Quad Cities Nuclear Power Station, Units 1 and 2
Renewed Facility Operating License Nos. DPR-29 and DPR-30
NRC Docket Nos. 50-254 and 50-265

Subject: Third Six-Month Status Report in Response to March 12, 2012 Commission Order
Modifying Licenses with Regard to Reliable Spent Fuel Pool Instrumentation (Order
Number EA-12-051)

**Third Six-Month Status Report for the Implementation of Order EA-12-051, Order
Modifying Licenses with Regard to Reliable Spent Fuel Pool Instrumentation**

RAI 2 SKETCH

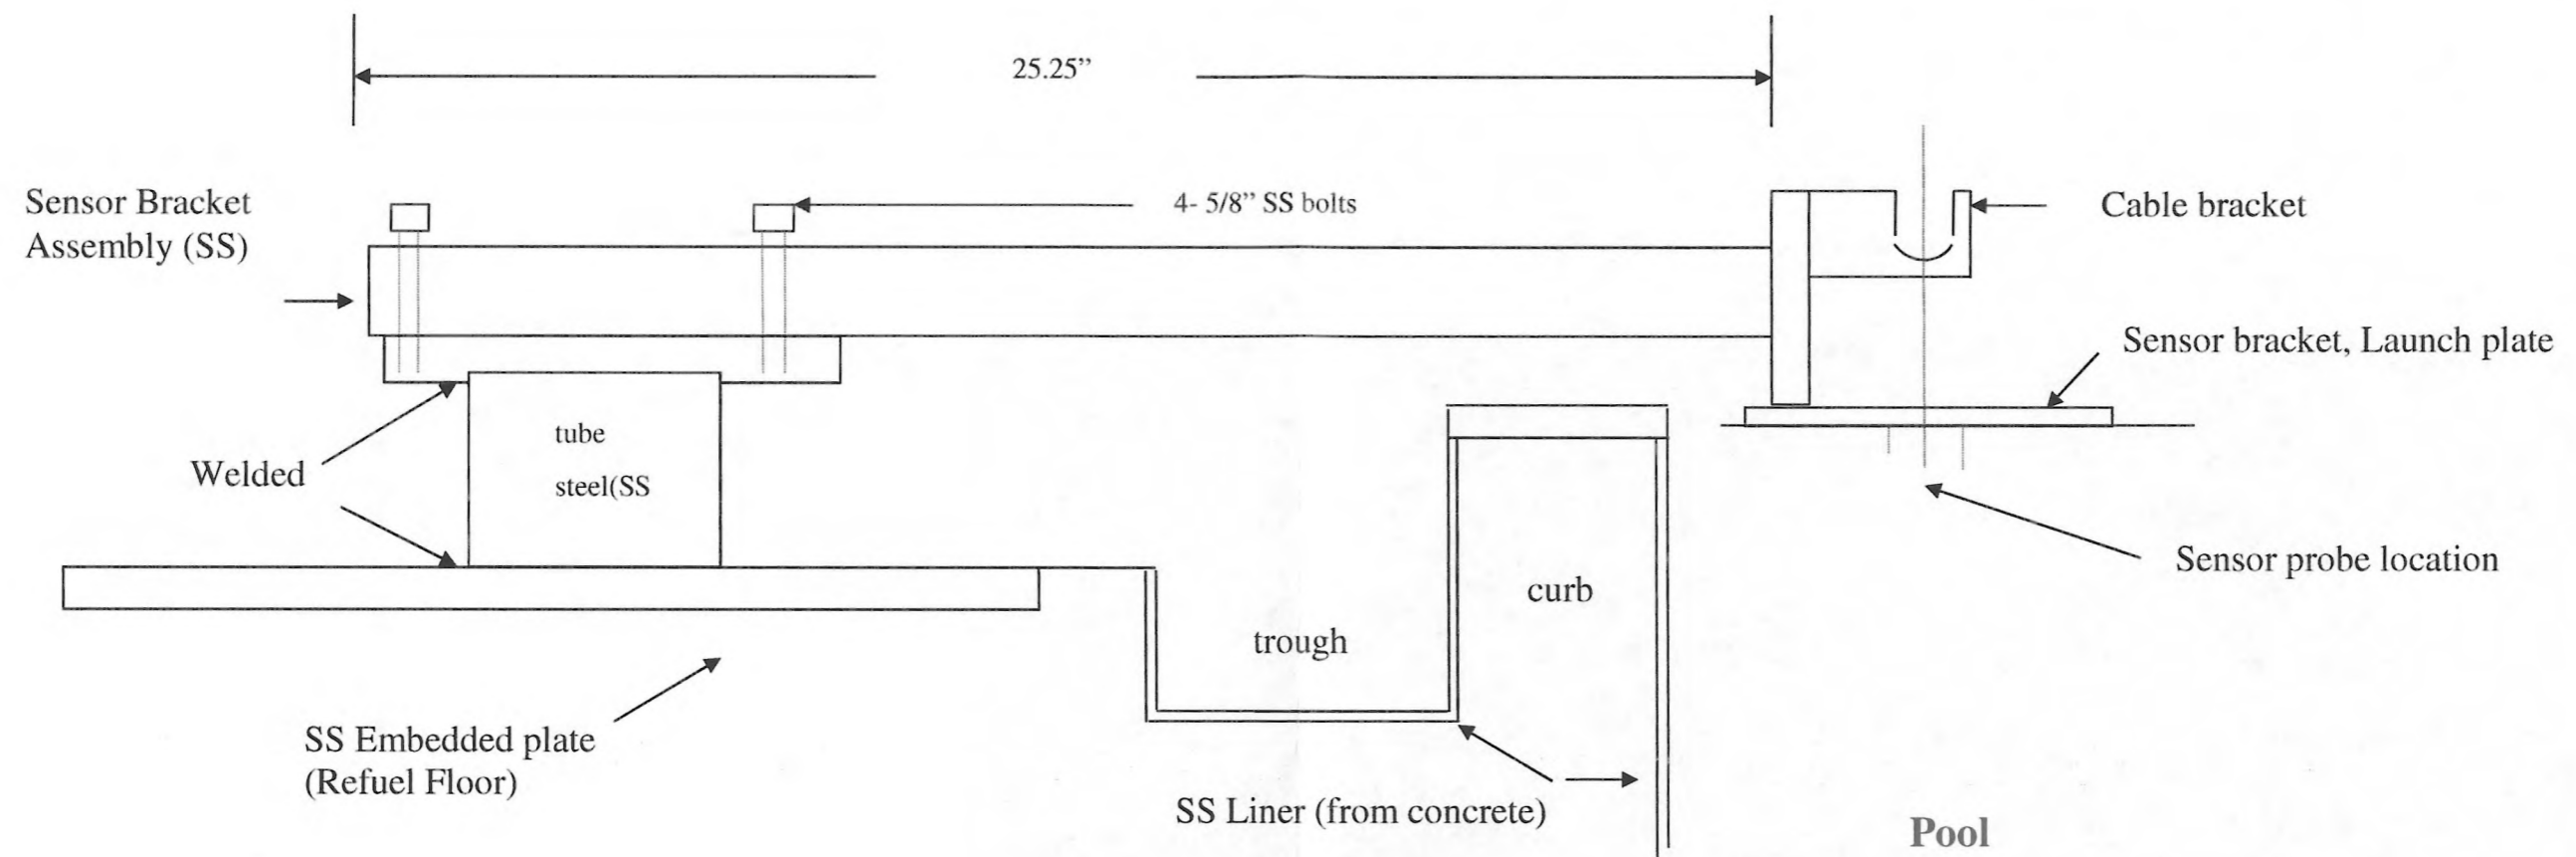
<p>the two points described in the NEI 12-02 guidance for this level.</p> <p>b) A clearly labeled sketch depicting the elevation view of the proposed typical mounting arrangement for the portions of instrument channel consisting of permanent measurement channel equipment (e.g., fixed level sensors and/or stilling wells, and mounting brackets). Indicate on this sketch the datum values representing L1, L2, and L3 as well as the top of the fuel. Indicate on this sketch the portion of the level sensor measurement range that is sensitive to measurement of the fuel pool level, with respect to the L1, L2, and L3 datum points.</p>	
--	--	--
